NLS980145 September 21, 1998

Inservice Inspection Relief Requests

Cooper Nuclear Station, NRC Docket 50-298, DPR-46

## Response to Request for Additional Information Cooper Nuclear Station Inservice Inspection Program Relief Requests

Drawing of Service Water Pump Discharge Head

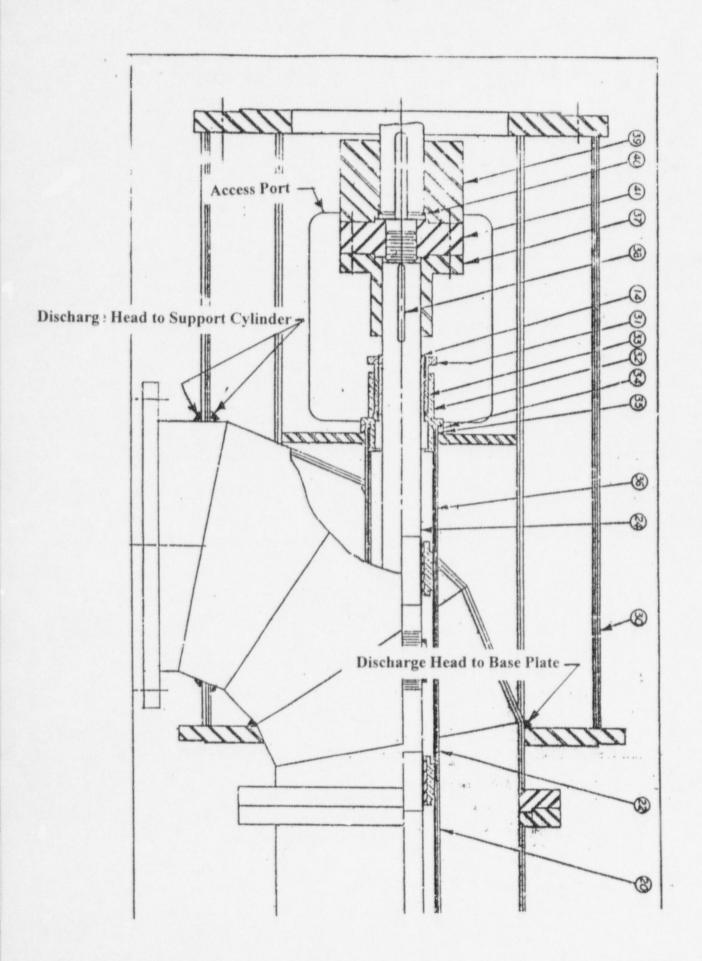
Code Case N-509 requires that the attachments selected for examination be **only those on the outside surface of the pressure-retaining component.** Additionally, the Code Case requires that only 10% of the applicable welds be examined, within other restrictions. Based on these requirements, it is unclear whether relief is necessary. Please discuss these discrepancies and, if relief is still necessary, provide drawings of the Service Water Pumps, depicting location and access restrictions for the integrally welded attachments.

Response. There are four Service Water Pumps. The integral attachment welds on one pump need to be examined to meet the requirements of Code Case N-509. The Service Water Pump discharge head is located inside a pump support cylinder which is welded to a base plate. The top of the pump support cylinder is the support for the pump motor. The inlet of the discharge head is welded to the base plate and then connects to the pump column. The outlet of the discharge head is welded to the pump support cylinder and then connects to the discharge piping. These welds are the integral attachments described in the relief request. The attachments are on the exterior of the discharge head (i.e. the pressure retaining boundary), but inside and outside of the pump support cylinder. An access port in the pump support cylinder is provided for maintenance purposes and is the only access to the inside of the pump support cylinder. Since the configuration of the pump support cylinder and discharge head limits the access to the attachment welds inside the pump support cylinder. the requirements of N-509 can not be fully met. Thus this relief request is still required. In RI-25, CNS proposed examining the accessible portions of the integrally welded attachments on an additional Service Water pump as an alternative which would compensate for the restricted access to the welds on the single Service Water pump.

Attachment 3 provides a Service Water pump configuration drawing that has been marked up to depict the location and access restrictions for the integral attachments.
